EPC Stormwater

Re: *Ellicott School Addition 2 bldgs*
Project No. 61183
PCD File No. PPR2250

Final Drainage Report Comments Response

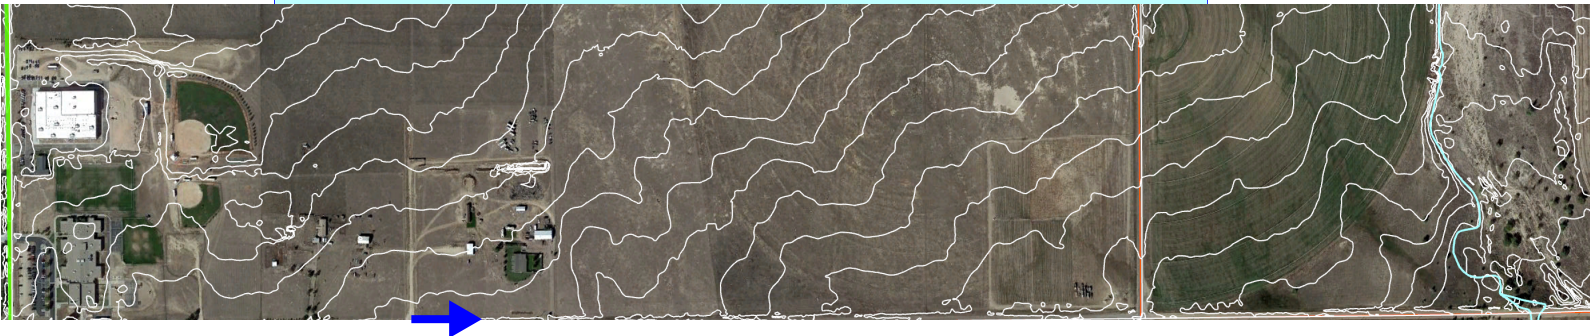
Please provide an overall reference map showing the overall property and indicating the outfall and downstream conveyance location.

4. An El Paso County GIS generated map showing the overall property and indicating the outfall and downstream conveyance location has been added to the updated report appendix.

**ELLICOTT SCHOOL
 ADDITION 2 BLDGS
 BMP AREA ID
 MAP**

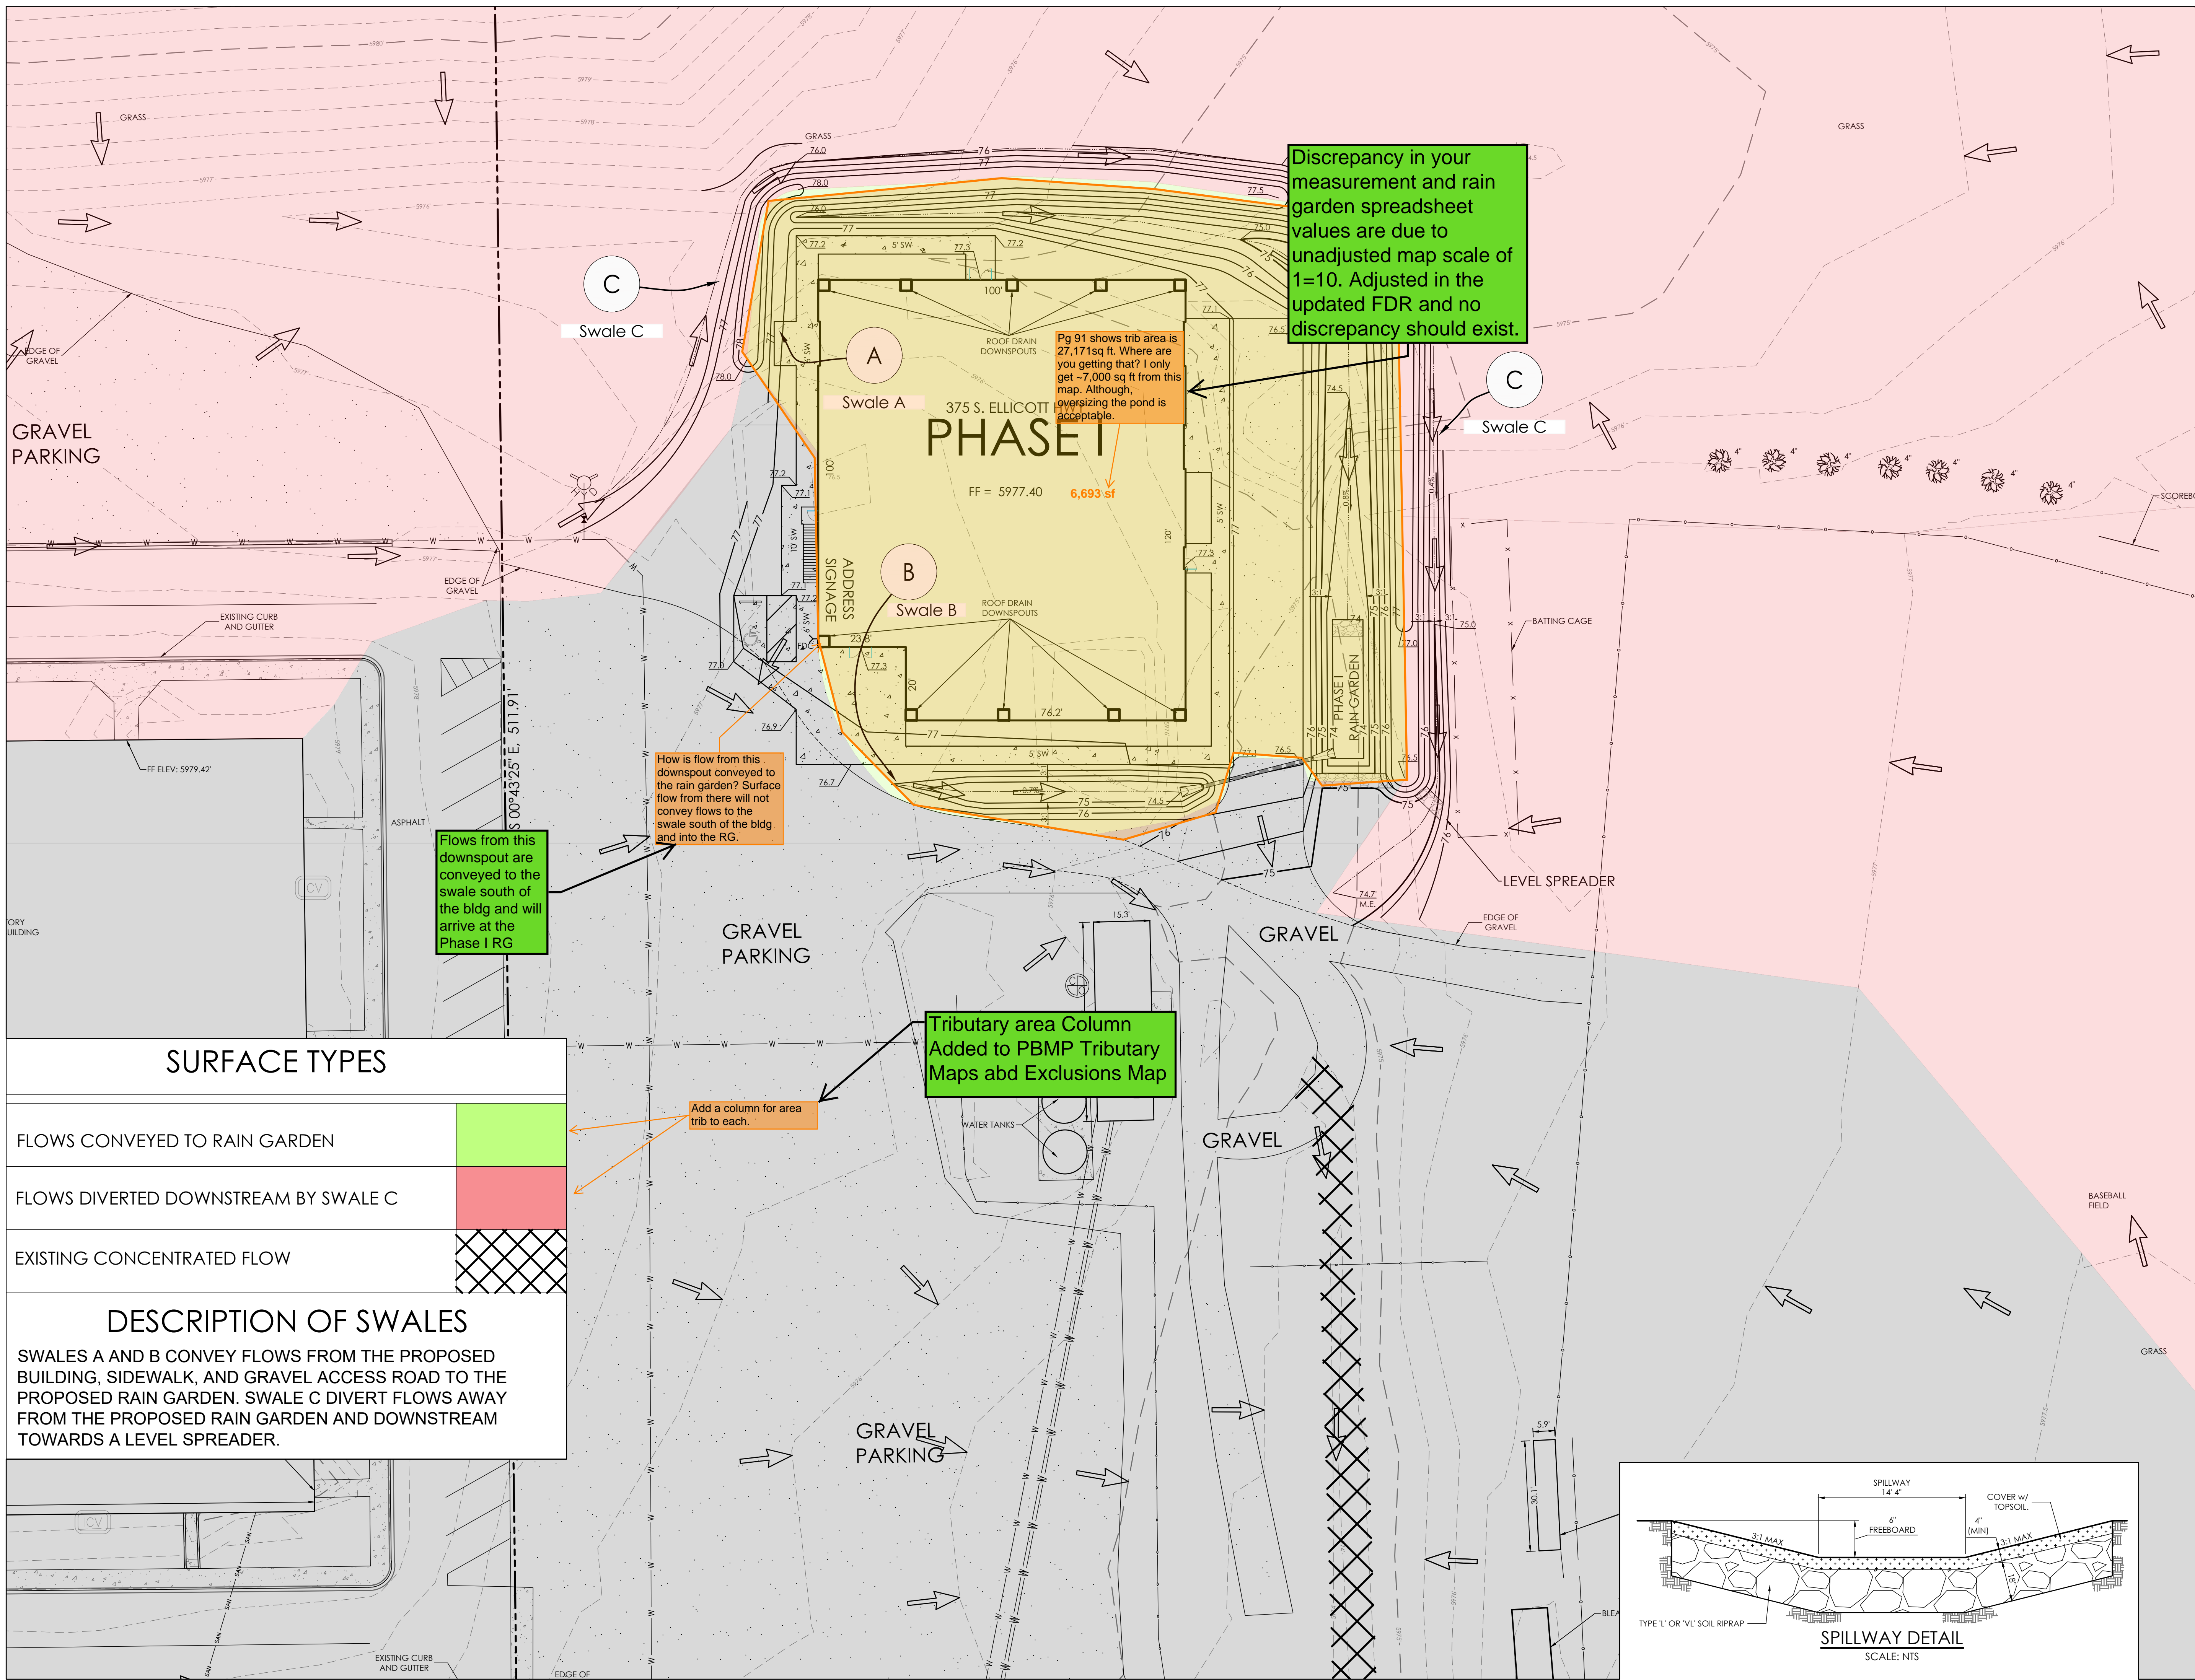
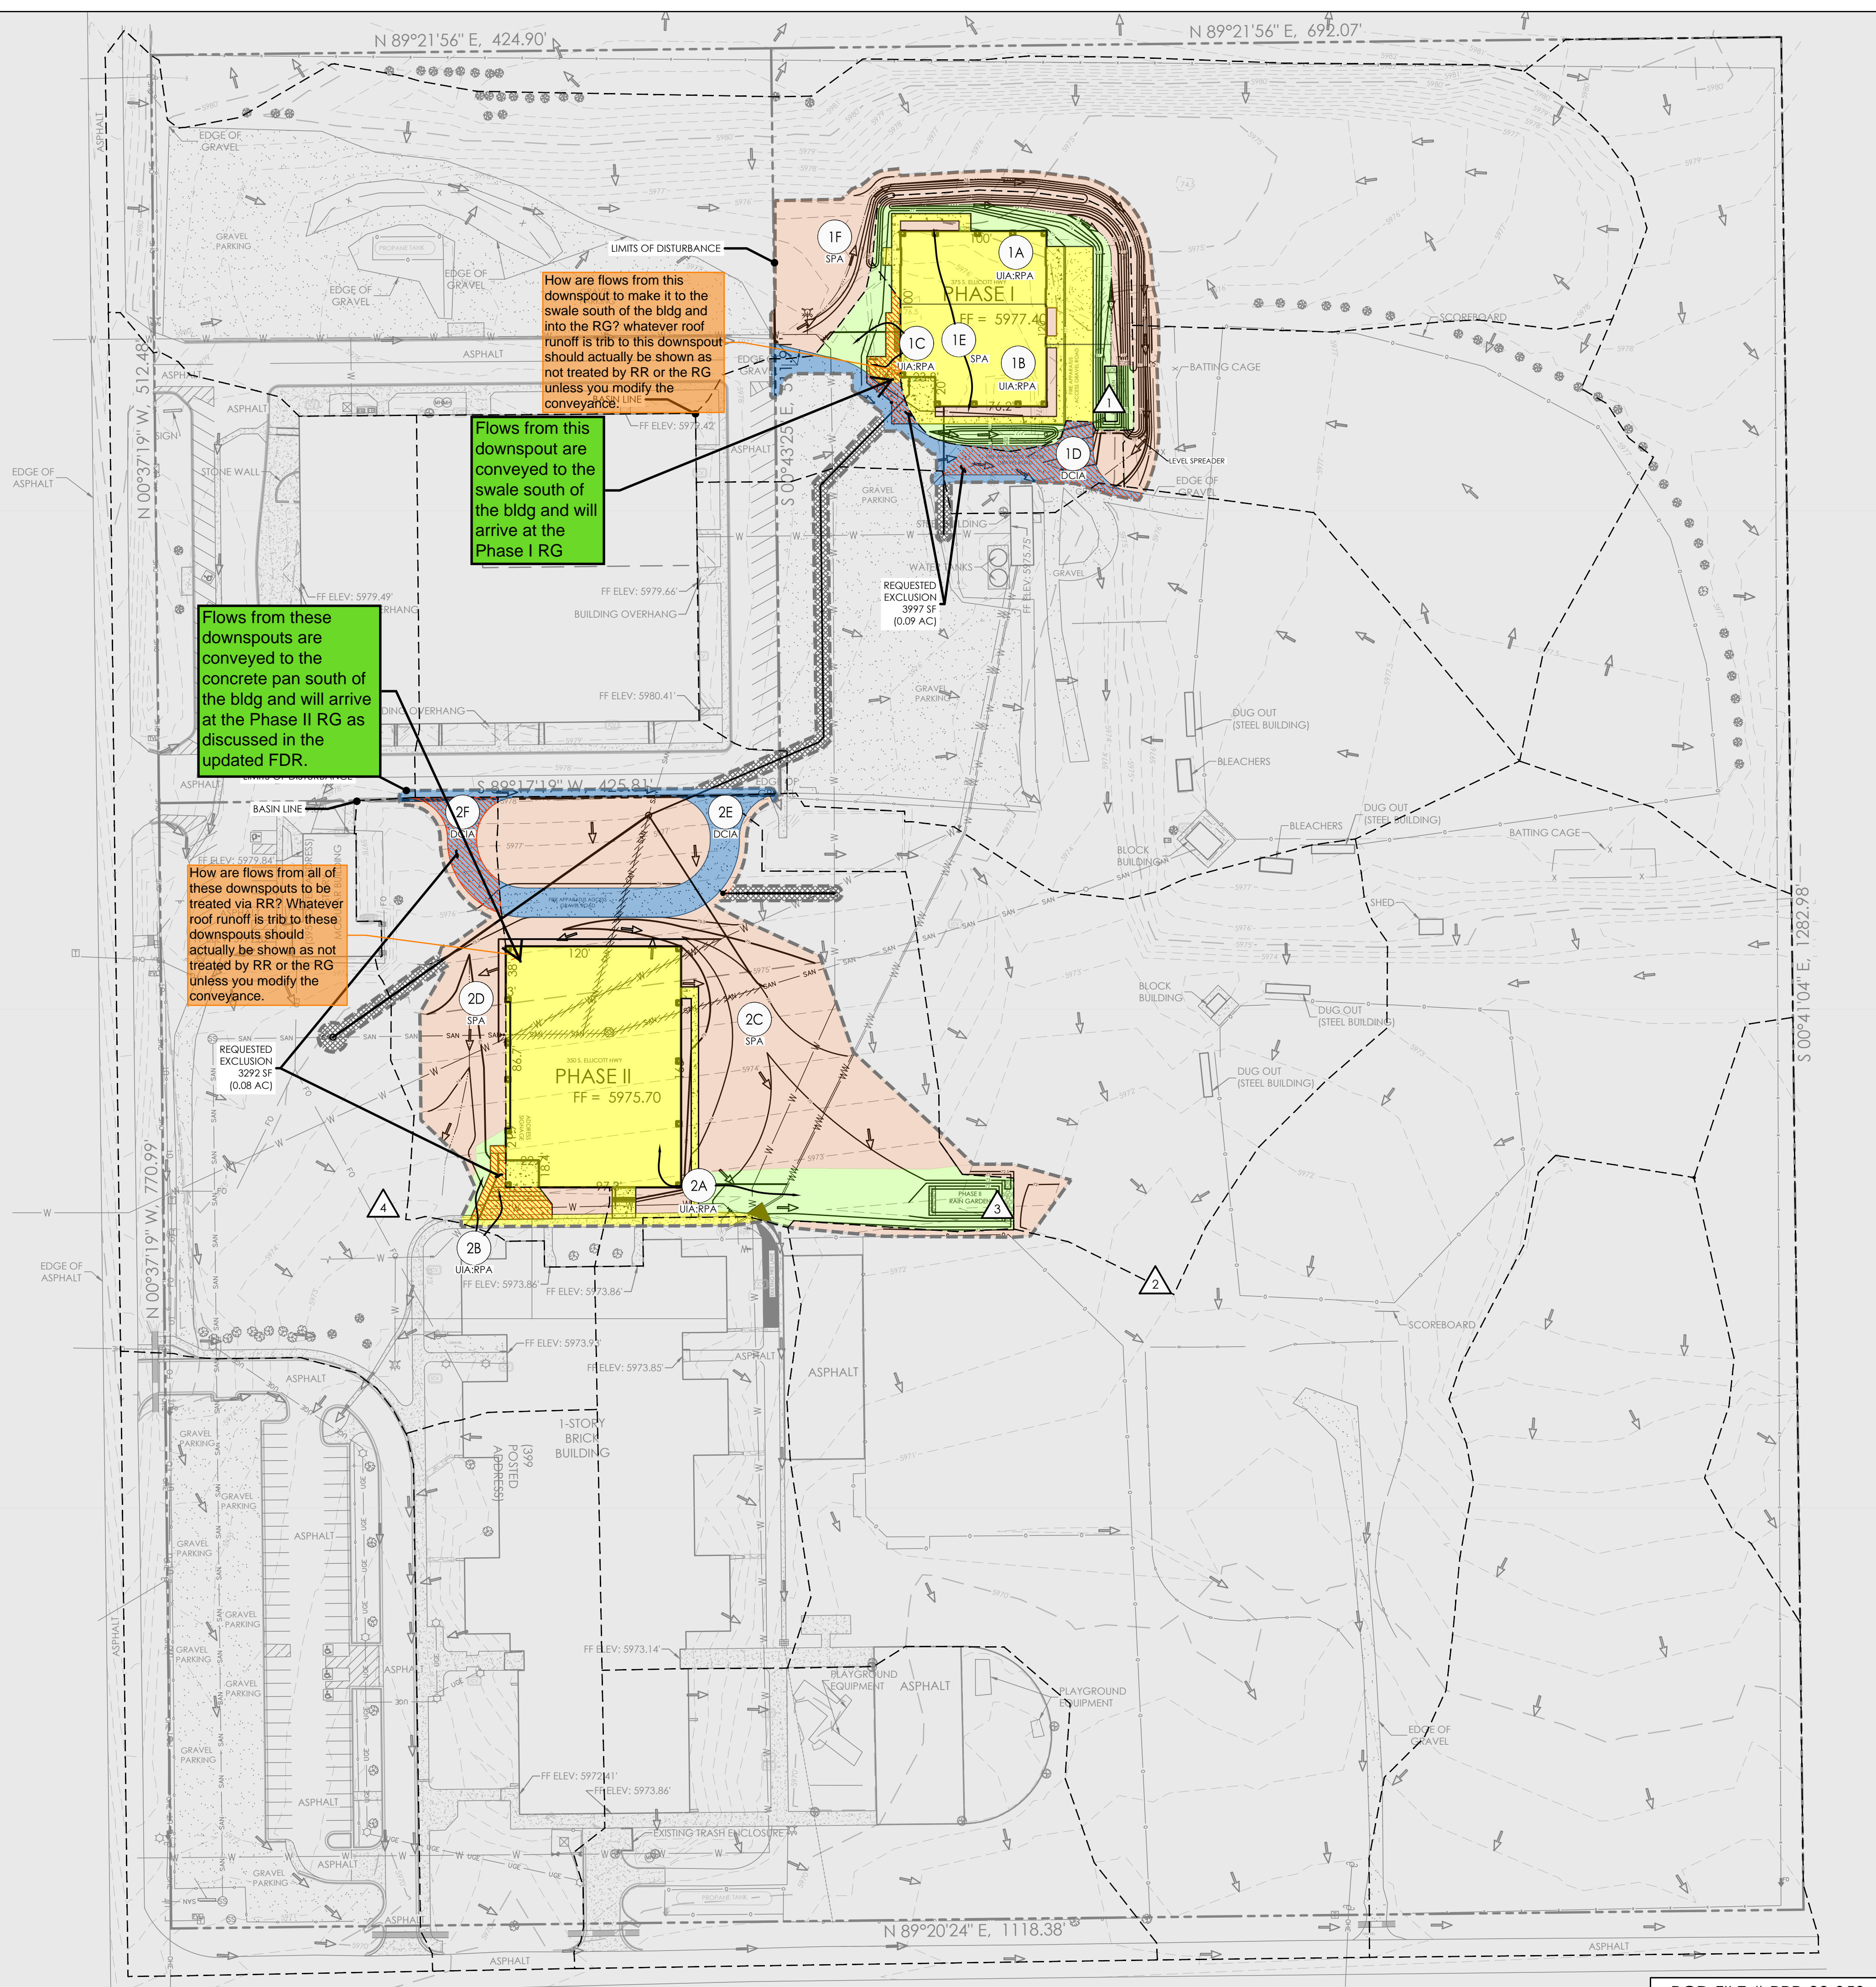
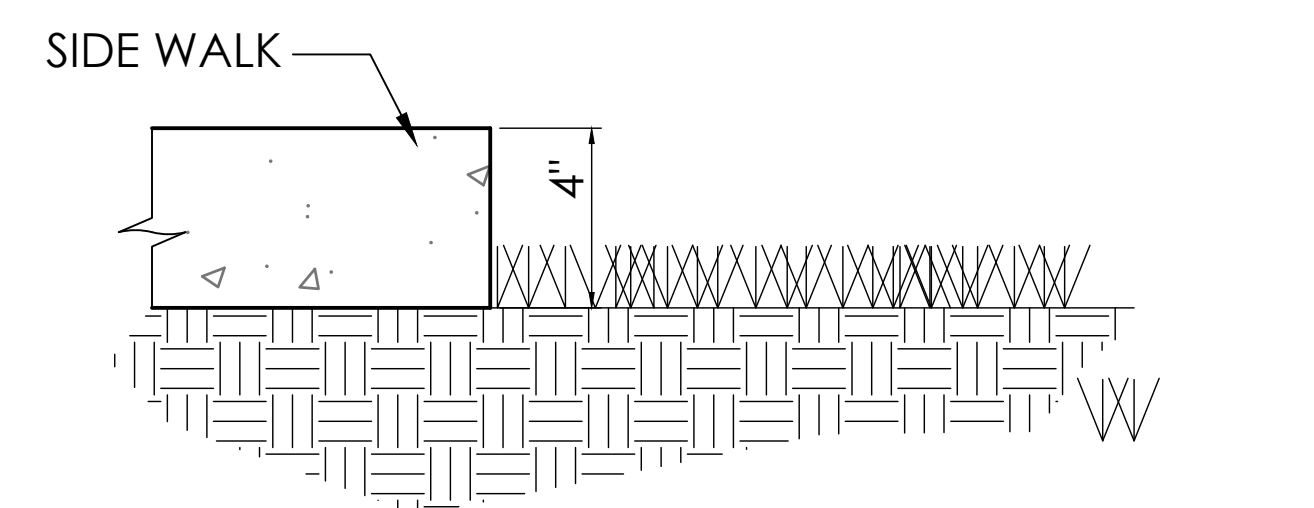
I agree with this statement but then all of the SPA's should be shown as receiving native seeding on the Landscape Plan, which they currently do not. Please update landscape plan accordingly.

General comment about WQ for the whole site:
 1) all areas within the LOD must be shown as having either WQ treatment or WQ exclusion. This has not been done on your maps yet. Show LOD on all WQ maps.
 2) Between these BMP Area ID Maps (runoff reduction) and PBMP Tributary Maps (rain gardens), there is double treatment shown for many areas. Please make the overall WQ picture for this site more clear by removing all areas treated by the rain gardens from the RR maps (ie: make another color on this map for "treated by rain gardens") and update the RR calc spreadsheet and report text.
 3) Please review MHFD Detail T-0. There appears to be a misunderstanding of what constitutes a DCIA.

Just for reference, the above comments are provided as further clarification to my previous comment (copied below in italics) that were not fully addressed with this submittal, so this isn't a new request. Plus so much of the design has changed since the last submittal (all runoff reduction calcs and maps are new), I am now able to clarify my previous comment further.

It is unclear which disturbed areas (and how much acreage) area not conveyed to the Rain Gardens. We need to know how much disturbed area is untreated and if there are any exclusions that apply to those areas.

So please create a basic overview map (or modify an existing drainage map) with color shading/hatching that shows areas tributary to each PBMP (pond, runoff reduction, etc) and those disturbed areas that are not treated by a PBMP, with the applicable exclusion labeled (ex: 20% up to 1ac of development can be excluded per ECM App I.7.1.C.1 and exclusions listed in ECM App I.7.1.B.#).

This statement has been removed along with all statements mentioning the runoff reduction base design standard. Runoff Reduction Standard is no longer employed, however, all pervious disturbed areas will receive native seeding as shown on the Landscape Plan.

Only WQCV Base Design standard is being used for WQ treatment utilizing the two proposed rain gardens.

Runoff Reduction Standard is no longer employed, however, all previous disturbed areas will receive native seeding as shown on the Landscape Plan. Only WQCV Base Design standard is being used for WQ treatment utilizing the two proposed rain gardens.
